Waimakariri District Council Proposed Waimakariri District Plan

Recommendations of the PDP Hearings Panel

Recommendation Report 34

Hearing Stream 12C Rezoning Requests – Large Lot Residential Zones

Appendix – Amended Mill Road ODP
DEV-MILL-APP1 – Mill Road Ohoka ODP

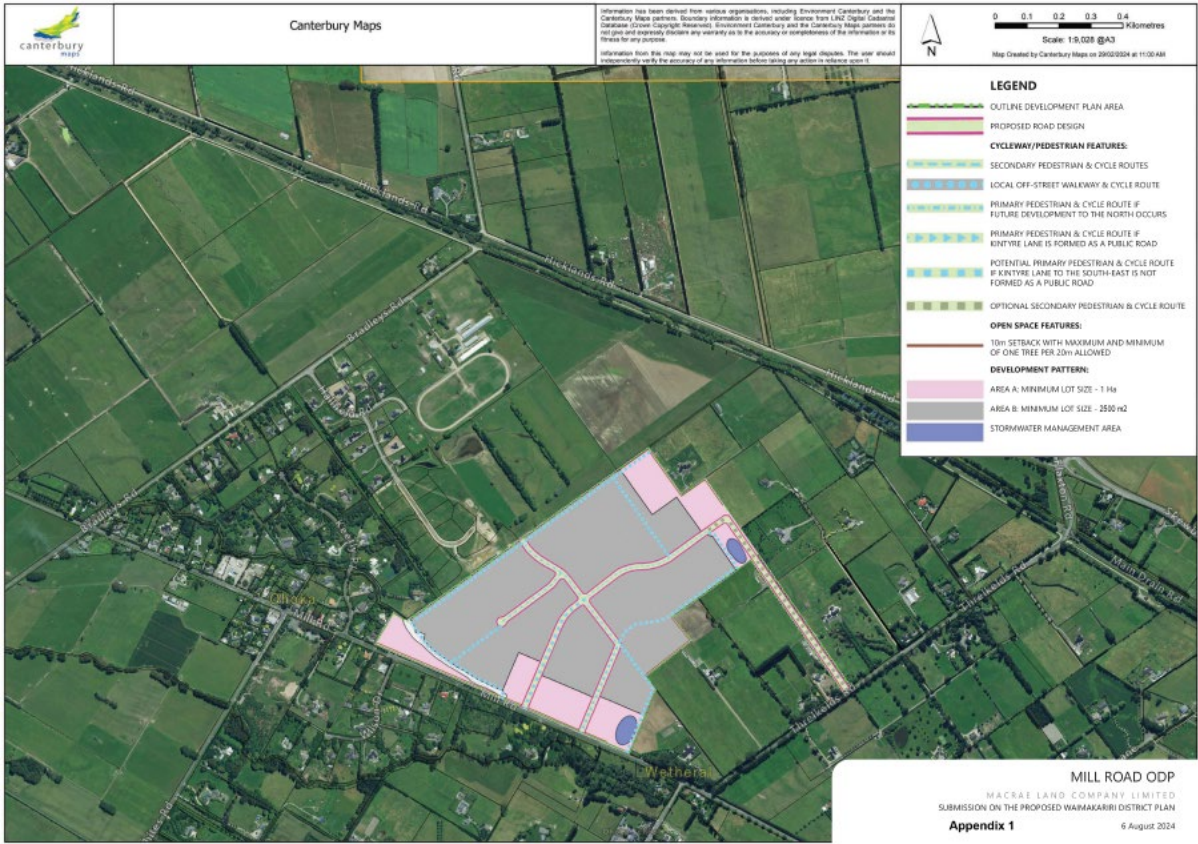
- Reece Macdonald¹⁵.
45. These submitters sought changes to the MILL - Mill Road Ōhoka Development Area provisions and ODP (created under PC17) as opposed to a new zoning. In summary, changes sought were as follows:

- Replace Density Area A located within the centre of the ODP area, specifically over 38 Kintyre Lane, with Density Area B. This would enable allotments within the centre of the ODP area to be a minimum size of 2,500m² (as discussed further below), rather than 1ha.

- Reduce the minimum allotment size for Density Area B from 4,000m² to 2,500m². No changes are proposed to the maximum number of allotments (81) or minimum allotment size for Density Area A (1ha) or the minimum average allotment size (5,000m²).

- Remove "character street with landscaping & planting provisions" from the MILL provisions.
 - Provide a new Local Road with potential primary pedestrian and cycle route connecting from the rear of the ODP area through 53 Threlkelds Road to Threlkelds Road.

46. The s42A report author recommended that the submissions be rejected (except for the Macdonald submission¹⁶ in relation to the internal road issue) because of concerns with the change in density in relation to stormwater and flood hazard management; changes to residential character; and design of the new access.

52. Overall, the Panel favours the evidence of MacRae Land Company in relation to this matter. We acknowledge that overall density will not in fact change and, as a

consequence, there will be no more dwellings within this area than already provided for the current ODP. While we understand the concern of the s42A report author in relation to overland flow paths and resurgence issues, we agree with MacRae Land Company that this can be appropriately managed through the natural hazard provisions of the PDP and the subdivision consent process. The evidence from the JWS¹⁷ in relation to the resurgence issue is that there are methods to manage it, and these methods were not used in the areas where it is currently a problem.

53. We also accept that it is necessary to amend the roading layout of the current ODP, given the legal issues with Kintyre Lane. We note that Mr Carr and Mr Binder agreed on this.

54. We also accept Ms Eveleigh's explanation in relation to the 'character street with landscaping and planting provisions' and agree with Mr Head's view that internal plantings will maintain an appropriate level of amenity. The s42A report author implied from Mr Binder's comments that the road carriageway would somehow be narrowed but having reviewed the evidence presented, we cannot see how this would be the case. Mr Binder merely noted that he was aware of some research that suggested carriageway trees have some positive traffic related effects. Mr Carr did respond to this in his supplementary evidence. He assessed the research on this matter and concluded it is not particularly persuasive. We agree.

55. As consequence, we recommend accepting the submission of MacRae Land Company, Ngaire Wilkinson and Laurie and Pamela Richards. We further recommend that the submission of Reece Macdonald be rejected.

56. The amended MILL – Mill Road Ōhoka Development Area provisions, including the ODP, are attached at Appendix 2.
